Re: Flyers Creek Wind Farm MP 08_0252 – Modification 3

The Proponent seeks a modification to the Project Approval under section 75W of the EP&A Act ("Modification 3") so as to:

- remove 4 wind turbines from the Project, reducing the total number of wind turbines authorised by the Project Approval from 42 turbines to 38 turbines; and
- make changes to associated access tracks and cabling and the alignment of the approved 33 kilovolt (kV) overhead power line.

Flyers Creek Wind Farm Layouts

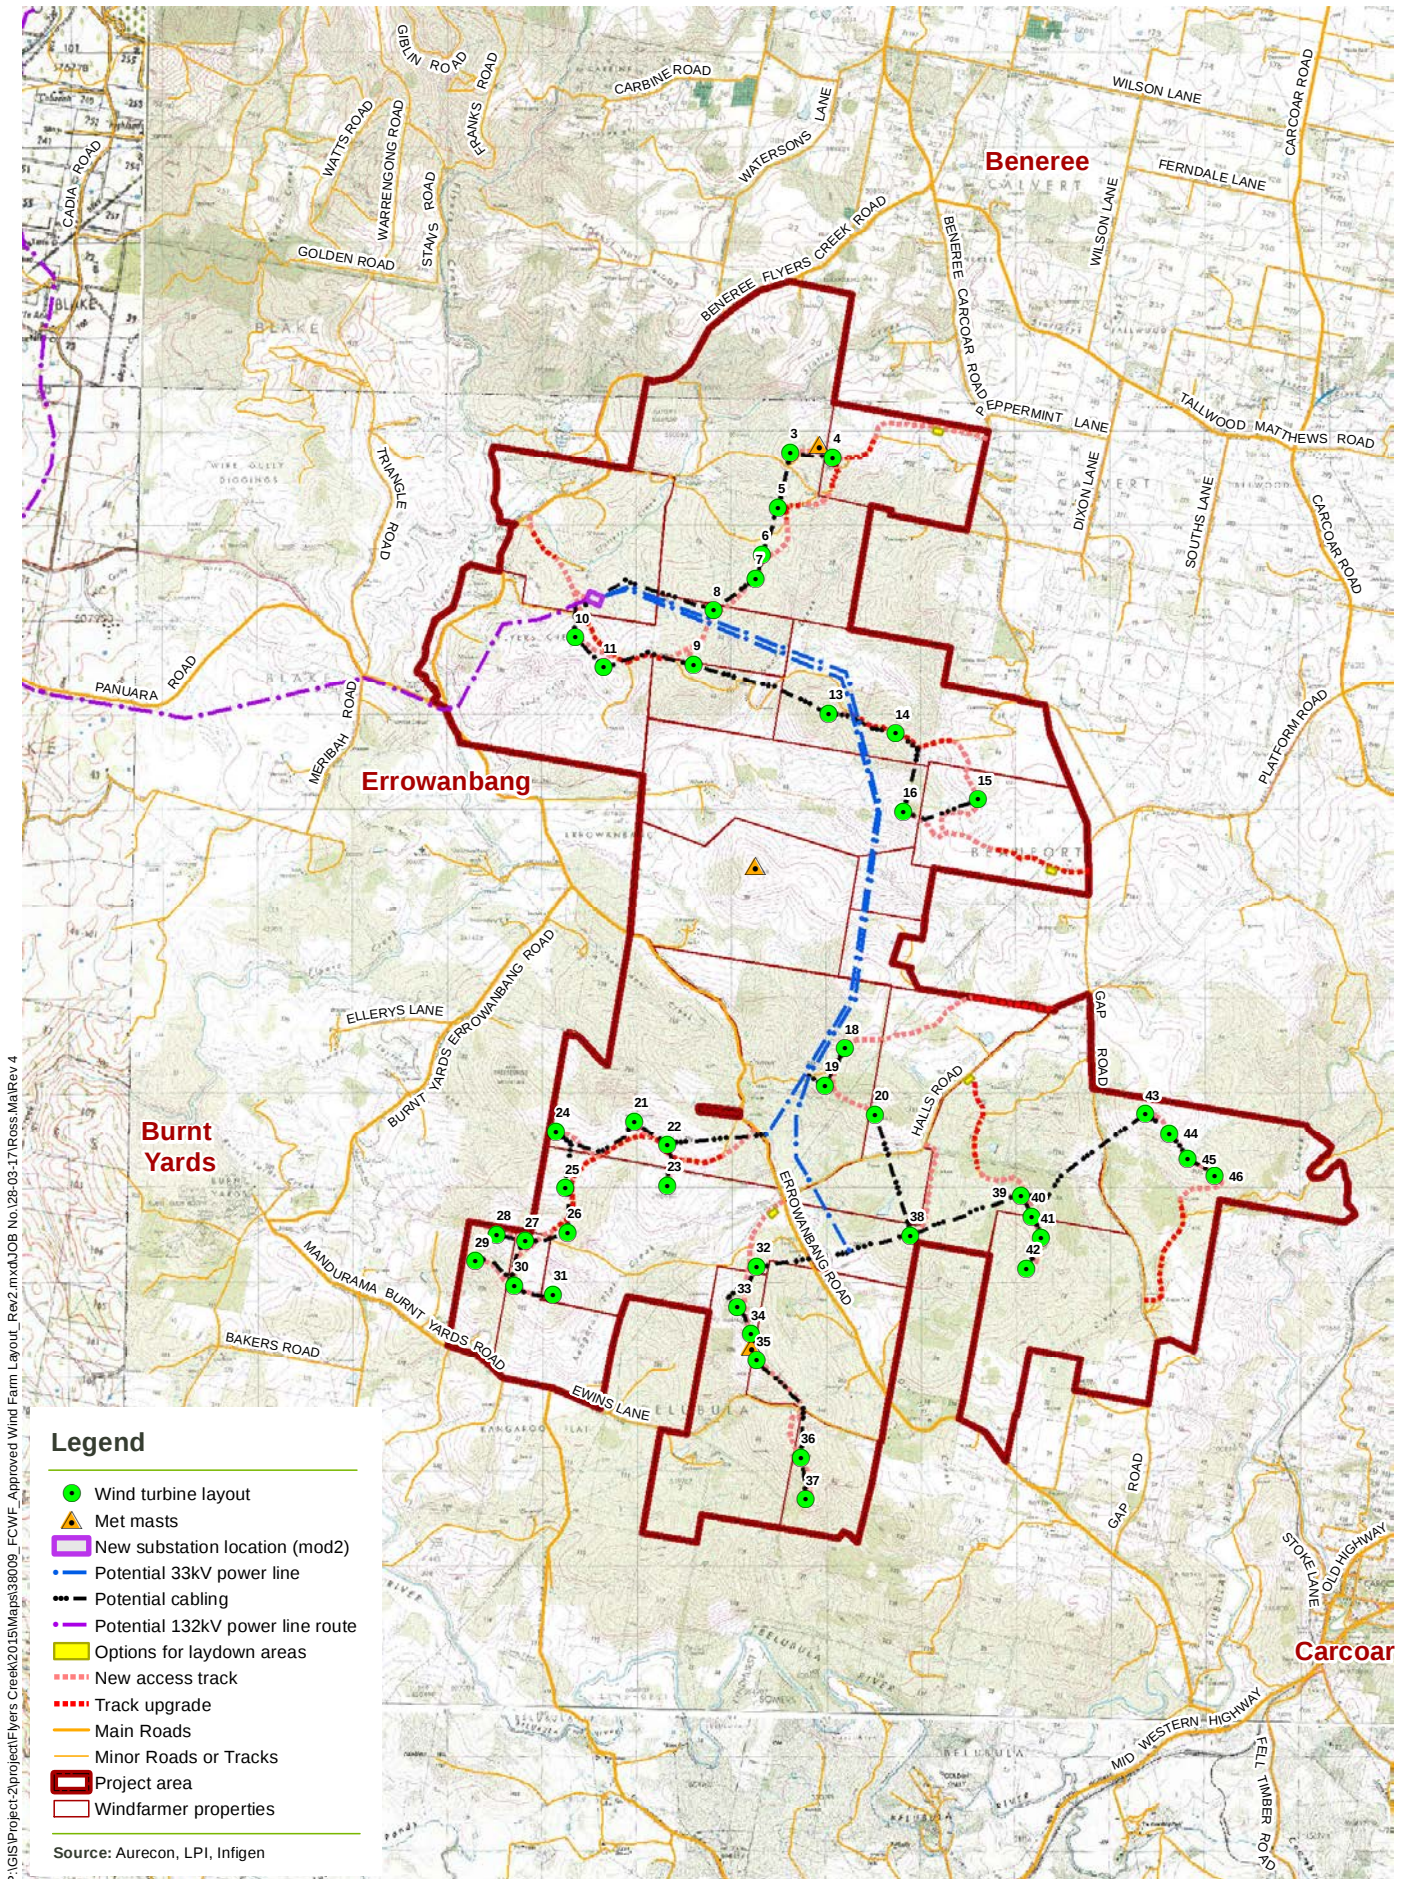
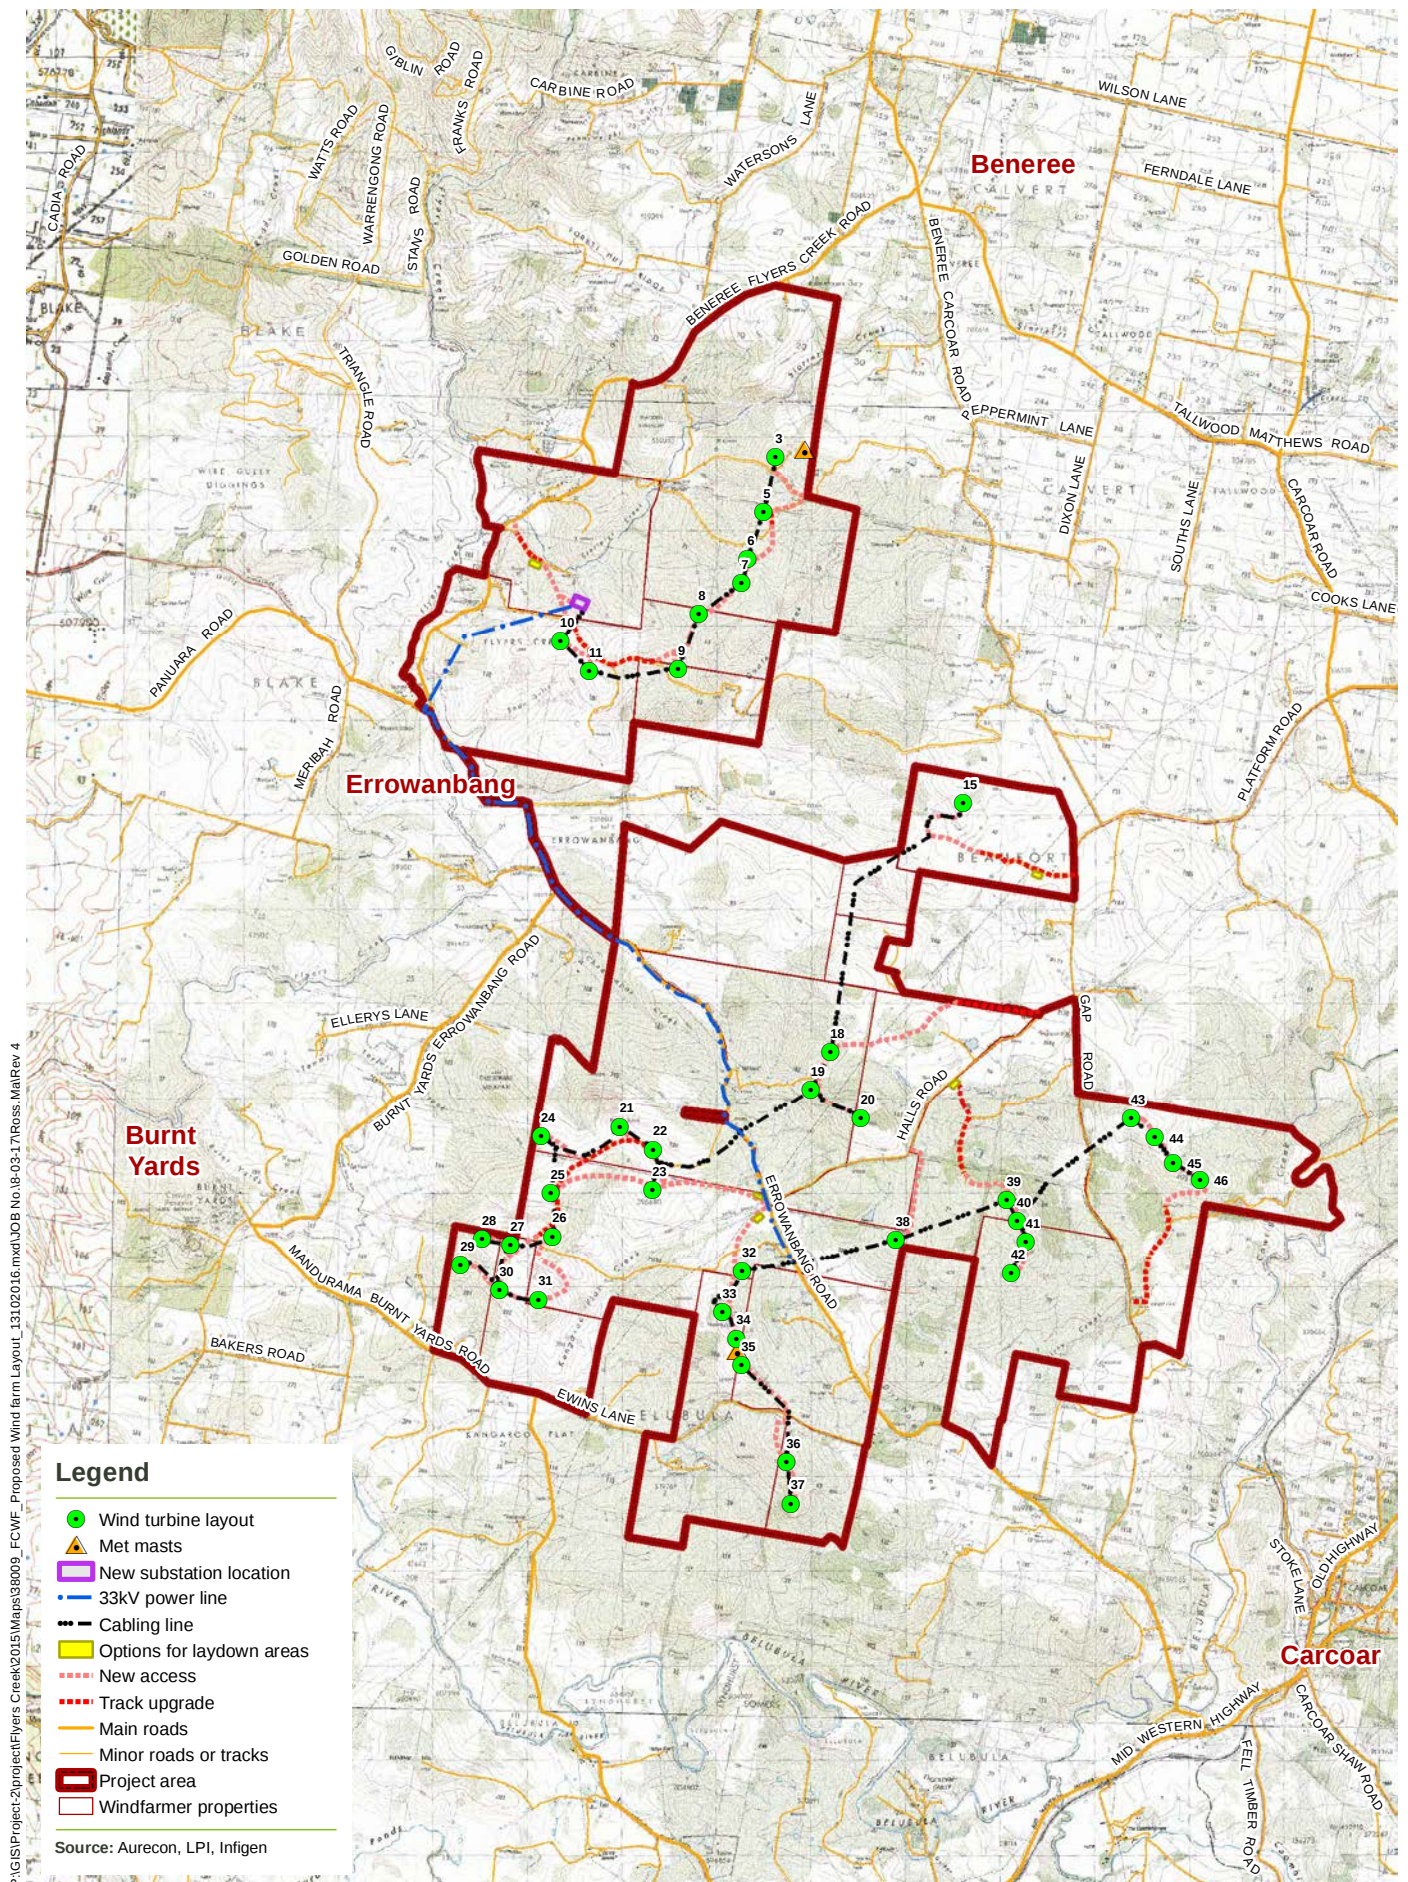
The Project Approval authorises the construction and operation of a duplicated 33kV overhead transmission line connecting the turbines in the southern half of the site to the substation and turbines in the north-western part of the site. Figure 1 of Appendix C shows the currently approved alignment in blue.

The Proponent seeks to modify the route alignment of the approved 33kV overhead power line from the alignment shown in Figure 1 of Appendix C to an approximately 100m wide route corridor following the alignment of the Errowanbang Road as generally shown in Figure 2 of Appendix C.

Approval is sought to locate the 33kV overhead power line required to transport power from the approved wind turbines to the approved substation anywhere within the approximately 100m wide route corridor indicated in Figure 2 of Appendix C. This approximately 100m wide route corridor has been selected as the Council is currently upgrading Errowanbang Road with works expected to be completed in mid to late 2018. The existing alignment of the Errowanbang Road will be subject to minor rerouting by the Council during the upgrade works. The approximately 100m wide route corridor will ensure that the 33kV power line will remain wholly or mostly within the road reserve for Errowanbang Road after the upgrade works are completed.

- **Access Tracks:** Replacement of the access tracks removed with new access tracks as shown on Figure 2 of Appendix C. These new access tracks are described below:
 - o Access track from turbine 3 to turbine 5 – amended location of access along existing track to ensure turbine 3 is accessible from turbine 5 as it is no longer accessible from the east;
 - o Access track from Errowanbang Road to turbine 22 – removal and alternative access proposed from Errowanbang Road to turbine 23 to make use of single entrance; and
 - o Access tracks between:
 - o Errowanbang Road and turbine 23;
 - o turbine 23 and turbine 22;
 - o turbine 23 and turbine 25; and
 - o turbine 26 and turbine 31,
 to allow for flexible access track configurations.
- **Lay Down Area:** Addition of a new option for a further laydown area (bring the total to 5) as generally shown in Figure 2 of Appendix C.

Modification 3 includes replacement of the underground cabling removed with new underground cabling as shown on Figure 2 of Appendix C (noting that the cabling will follow the access track route corridor where not separately shown). The new underground cabling is described below:

- cabling between turbine 10 and the approved substation (which was relocated as part of Modification 2);
- cabling connecting turbine 15 and turbine 18;
- cabling between turbine 19 and Errowanbang Road; and
- amendment to the cabling between Errowanbang Road and turbine 22 to follow existing access track.
